July 2, 2015
	Alberta Technology Center
Owner:	The City of Tuscaloosa
Owner's Project No:	A15-0513
Architect:	Ward Scott Architecture, Inc.

Addendum No. 3 - Structural Items

1 NORTH ELEVATION
1/4" = 1'-0"

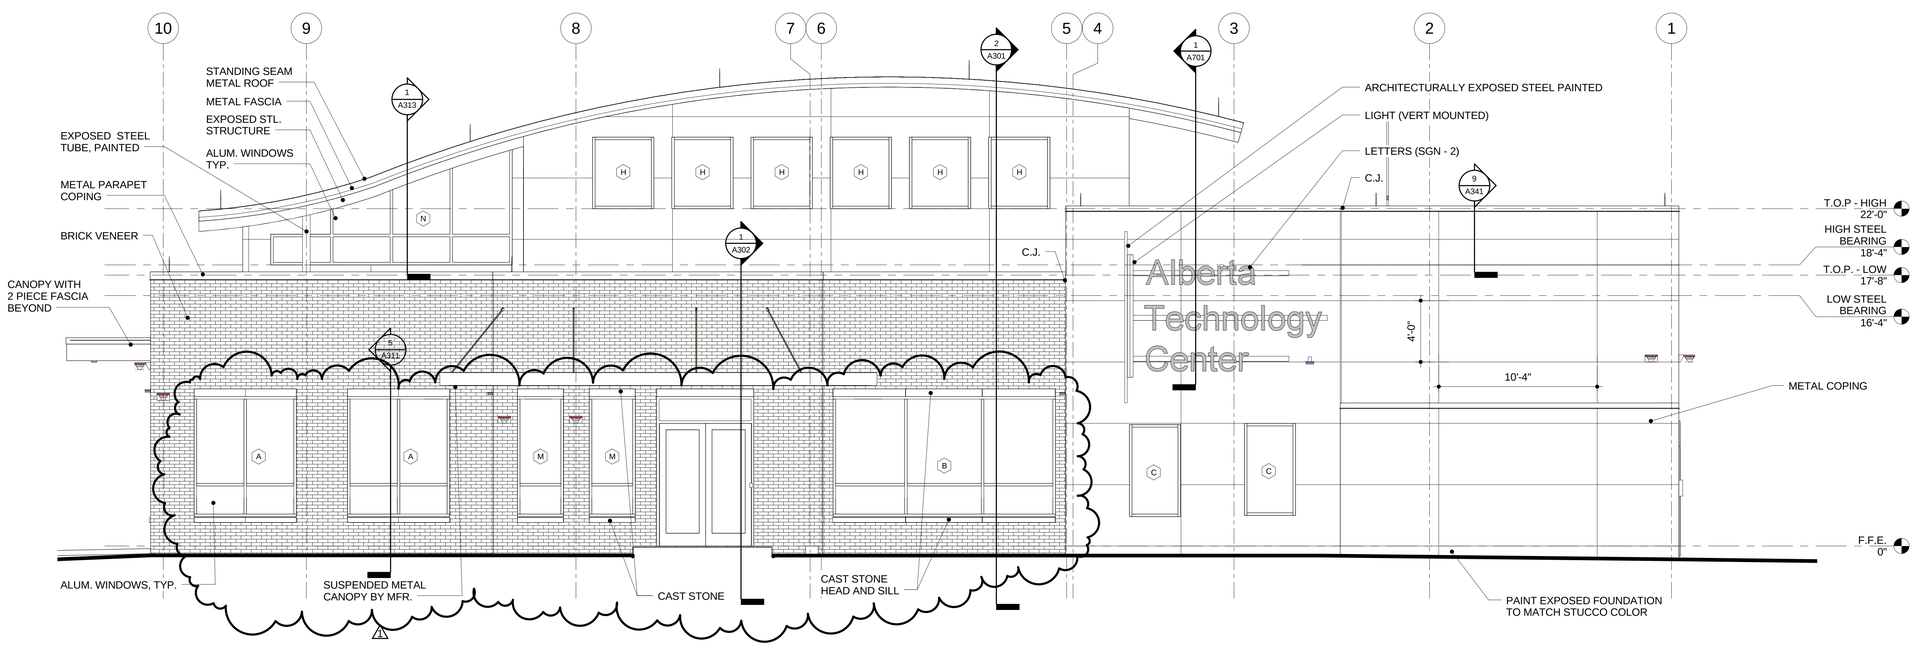
8. A201 Exterior Elevations. Detail 1 - window size adjustments, new door transom and cast stone headers (typical).
9. A202 Exterior Elevations. Detail 2 - window size adjustments, new door transom and cast stone headers (typical).

5 WALL SECTION - WINDOW - A
3/4" = 1'-0"

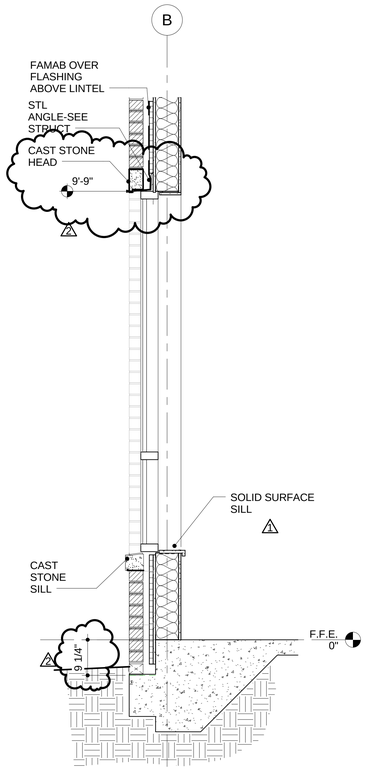
10. A311 Wall Sections. Note storefront windows in masonry wall to be typical per new detail 5/A311. Wall section at Cast Stone window (Detail 4) has been modified. Details 6, 7, and 8 have been deleted.

10 PLAN DETAIL
1" = 1'-0"

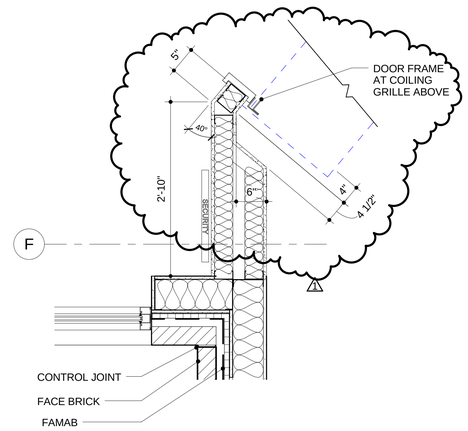
c. Detail 9 shows metal coping at stucco wall.
    d. Detail 10 indicates new interior framing dimensions.
12. A331 Section Details. Detail 4 and 5 have been replaced.

7 PLAN DETAIL - ROOF PARAPET
1 1/2" = 1'-0"

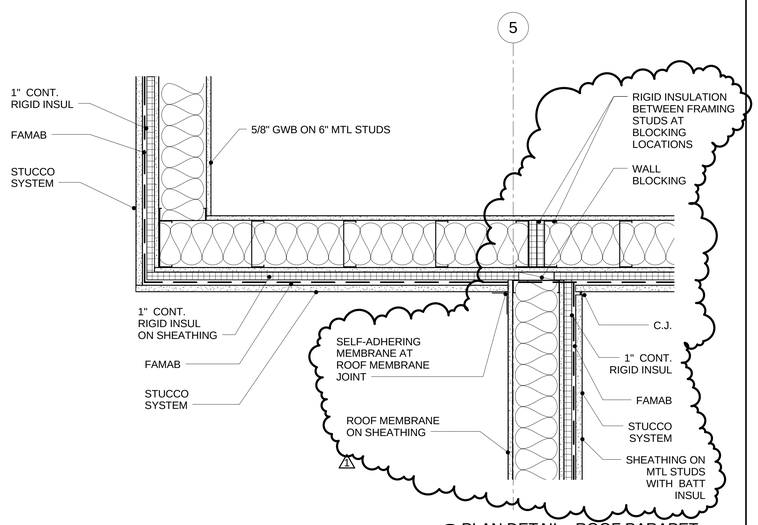
11. A312 Plan Details.
    a. Detail 1 indicates, new cast stone profile and sill details.
    b. Detail 7 indicates additional FAMAB and insulation detailing at intersecting walls.

8 PROFILE - CAST STONE (EXTERIOR WINDOW JAMB)
6" = 1'-0"

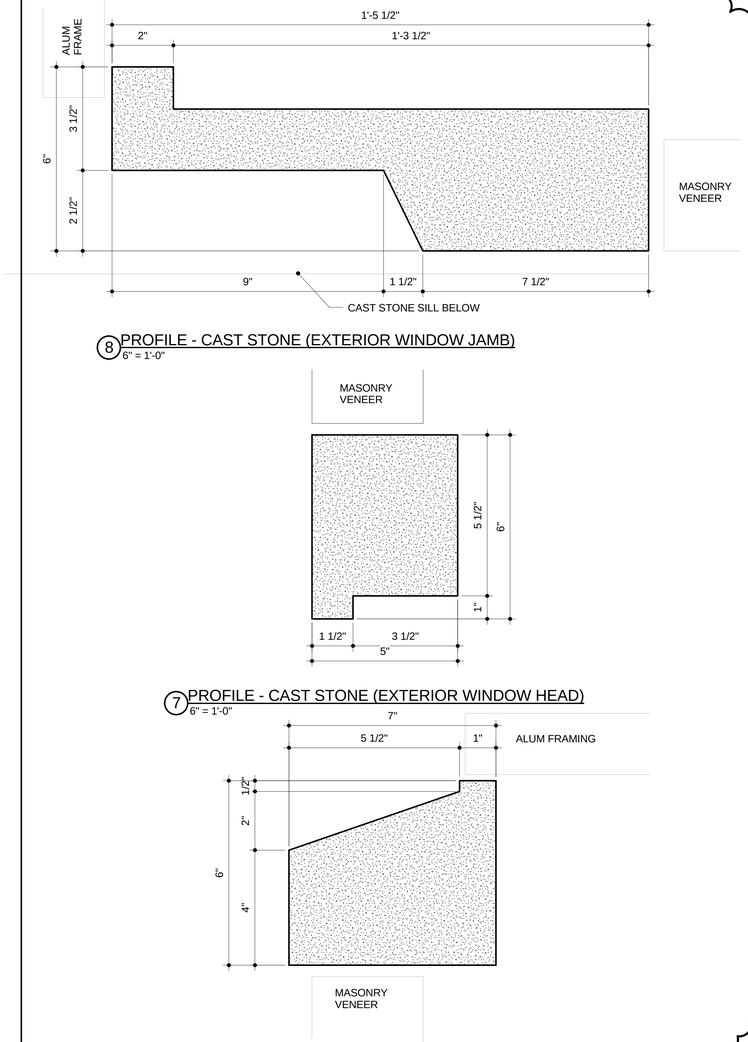
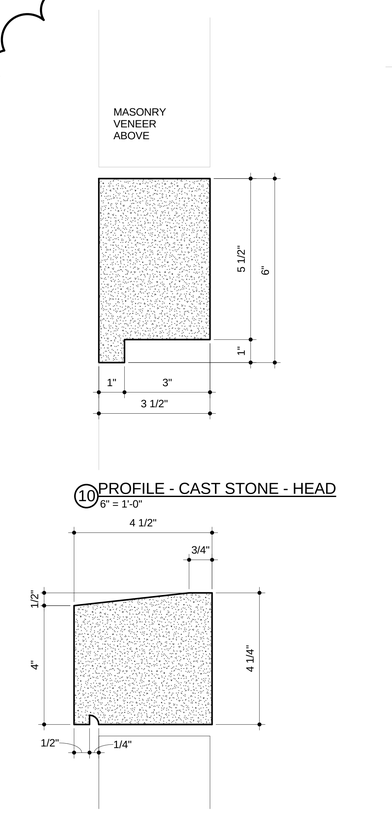
13. A332 Typical Details and Profiles. Cast stone profiles have been revised for details 6, 7, 8 , 9, and 10. Note Detail 2 for FAMAB compatible sealant.
